**PLANNED UNIT DEVELOPMENT
& SUBDIVISION STAFF REPORT**

Date: December 21, 2017

PAM Mid Town Subdivision

Subdivision approval to create one legal lot of record and Planned Unit Development approval to allow a new off-site parking lot to accommodate an existing medical clinic.

SITE PLAN

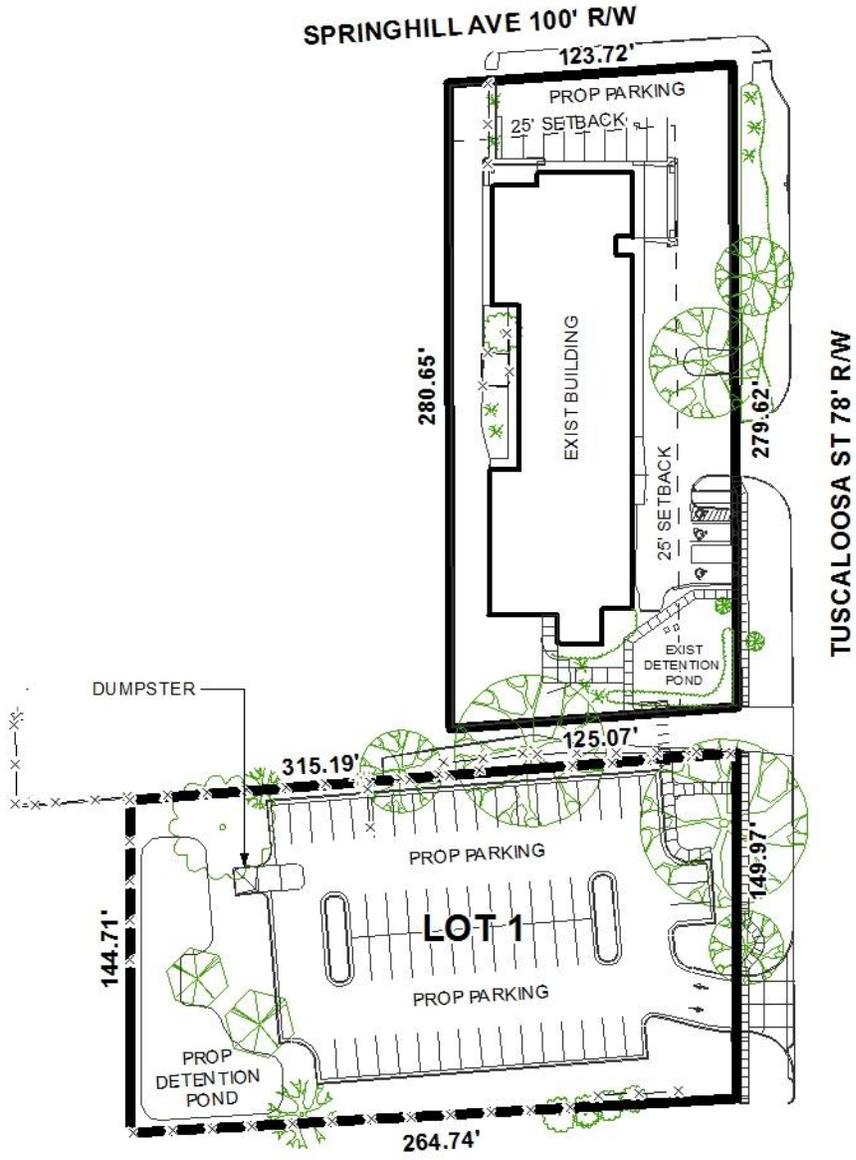
The proposed site plan will negatively impact access to the traffic signal that aligns with Stanton Road at Spring Hill Avenue. If this proposed development removes the asphalt on their property within the drive aisle, the traffic signal for that approach will have to be removed. The developer must coordinate with Traffic Engineering at time of construction for the City to remove the necessary equipment. The 2005 subdivision application for this site limited the corner parcel to the one shared driveway with the adjacent development. As a means of access management, the concrete pavement in the right-of-way of Spring Hill Avenue between the sidewalk and the curb should be removed and landscaped to prevent its use as a driveway. Also, the concrete apron for the drive aisle that is to be modified should be removed and grassed adjacent to the owner’s property to further prevent its use as a two-way driveway. In conjunction with the signal removal, the City will designate the driveway portion remaining on the adjacent property as an entrance only driveway. New on-site parking, including ADA handicap spaces, shall meet the minimum standards as defined in Section 64-6 of the City’s Zoning Ordinance.

Revised for the November 16th meeting: No additional information, therefore previous comments stand. If proposed plan to landscape to the west of the existing building is abandoned and remains unchanged, changes to the traffic signal will not be required. Removal of the concrete in the right of way of Spring Hill Avenue (between sidewalk and curb) is still a requirement to maintain the condition of the previous approval only allowing the one access point to Spring Hill Avenue.

Regarding the PUD request, the applicant proposes to expand the footprint of the existing medical clinic by enclosing an entryway and former drive-thru porte-cochère. Additionally, the site plan illustrates curbing where the original Administrative PUD site shares access and parking with the adjacent site, thus eliminating reciprocity. As such, additional parking is necessary to accommodate off-street parking requirements for a medical clinic in a B-1, Buffer Business District. A 20' wide portion of the adjacent lot inhibits cross access between the original PUD site and a neighboring lot; therefore, the applicant also proposes to develop an off-site parking lot to satisfy these requirements.

The site plan illustrates 11 on-site parking spaces and 62 off-site parking spaces which, when combined, meet the minimum off-street parking requirements regarding number of parking spaces, and stall length and width. Three on-site parking spaces are designated as van accessible and also meet dimensional requirements.

Curbing is illustrated where vehicles could extend beyond existing and proposed parking facilities.

Adequate 24' two-way aisle access and a 24' wide driveway providing access to and from Tuscaloosa Street are illustrated for the proposed parking lot. It should be noted however, that similar aisle configuration on the original PUD property is, at times, reduced by one (1) to seven (7) feet. While access and maneuvering may not meet current requirements, the site was previously expanded in compliance with the approved Administrative PUD.

A note has been placed on the site plan iterating compliance with parking lot lighting requirements per Sections 64-4.A.2. and 64-6.A.3.c. of the Zoning Ordinance, but a photometric plan showing compliance with Section 64-6.A.8. will nevertheless be required prior to the approval of any land disturbing or construction activities.

A proposed sidewalk is illustrated on the site plan along Tuscaloosa Street where the proposed lot has frontage; and existing sidewalks along both streets to which the original PUD site has frontage are also illustrated. Also, a pedestrian safety walkway is proposed across 20' of the

The proposed changes to the original PUD site do not necessitate its full compliance with Tree and Landscaping ordinances at this time, but trees and landscape area are illustrated. Compliance with Tree and Landscaping ordinances will, however, be required for the proposed lot on which off-street parking will be developed. A note stating as much has been provided on the site plan, and Staff has received a preliminary Tree and Landscaping Plan.

While landscape area appears to meet the minimum applicable requirements, Staff cannot determine compliance with the tree requirements. Tree credit data is not clearly identified and it appears that several off-site trees are being included for credit. As such, revision of the Tree and Landscape plan to adequately identify the amount and types of trees on site will be required prior to the approval of any land disturbing or construction activities.

It should also be noted that any changes to the site plan as a result of comments from Traffic Engineering will need to be illustrated on a revised site plan.

A dumpster pad is depicted on the site plan along with a note stating compliance with Section 64-4.D.9. of the Zoning Ordinance regarding enclosure and sanitary sewer connection requirements. This information should be retained on any revised site plan; or, if necessary, a note stating curbside pickup will be utilized instead may suffice.

Finally, the site is adjacent to several R-1, Single-Family Residential properties, thereby requiring a residential buffer in compliance with Section 64-4.D.1. of the Zoning Ordinance. A 6' wooden privacy fence is illustrated on the site plan where the site abuts residential property and is sufficient to comply with these buffer requirements, but the applicant should note that a separate building permit will be required for any fence(s) constructed on the property.

Staff received a revised site plan illustrating the adjacent site with which it shared PUD approval regarding access (2011 Spring Hill Avenue) (the revisions were received too late in the review process to allow Traffic Engineering and Engineering to revise their comments). Also, per previous Traffic Engineering comments, the applicant has abandoned their plans to landscape the aisle with which the two sites shared access, thus making no changes that would inhibit safe access to/from Tuscaloosa Street via the 20' wide drive between the proposed PUD sites (2001 Spring Hill Avenue and 137 Tuscaloosa Street). As a result, no changes to the traffic signal facilitating such access will be required; therefore, approval of the Subdivision and PUD may now be appropriate. It should be noted, however, that the removal of concrete in the right-of-way of Spring Hill Avenue (between sidewalk and curb), thus allowing only one access point to Spring Hill Avenue, remains a condition of approval per Traffic Engineering. Revision of the site plan to illustrate this condition should be required.

- 1) *provision of a photometric plan in compliance with Section 64-6.A.8. of the Zoning Ordinance at the time of permitting;*
- 2) *provision of a Tree and Landscaping plan in compliance with Section 64-4.E.3. of the Zoning Ordinance at the time of permitting;*

- 4) *compliance with Traffic Engineering comments: (No additional information, therefore previous comments stand. If proposed plan to landscape to the west of the existing building is abandoned and remains unchanged, changes to the traffic signal will not be required. Removal of the concrete in the right of way of Spring Hill Avenue (between sidewalk and curb) is still a requirement to maintain the condition of the previous approval only allowing the one access point to Spring Hill Avenue.);*

DETAIL SITE PLAN

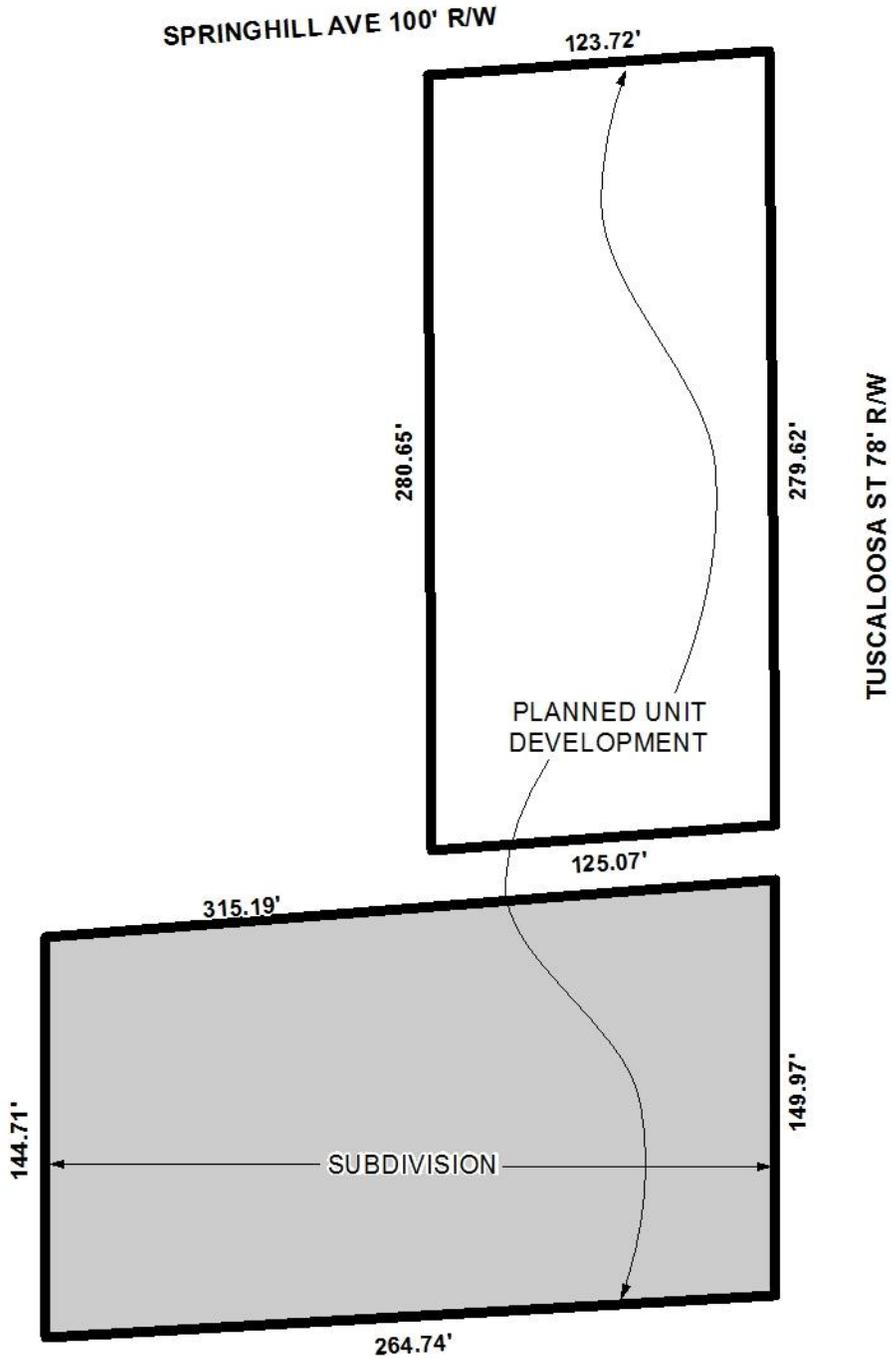
The proposed lot has frontage on Tuscaloosa Street, a minor street with curb and gutter requiring a 50' right-of-way width. The preliminary plat illustrates a 78' right-of-way width at this location; therefore, no additional dedication should be required.

The 25' minimum building setback is illustrated on the preliminary plat and should also be retained on the Final Plat, if approved.

With regards to access management, a note should be placed on the Final Plat, if approved, stating the lot is limited to one curb cut to Tuscaloosa Street, with any changes to its size, location or design to be approved by Traffic Engineering and conform to AASHTO standards.

A house and structural remains are illustrated on the preliminary plat; therefore, it should be noted that demolition permits will be required to remove the existing house prior to the approval of any other construction or land disturbance requests.
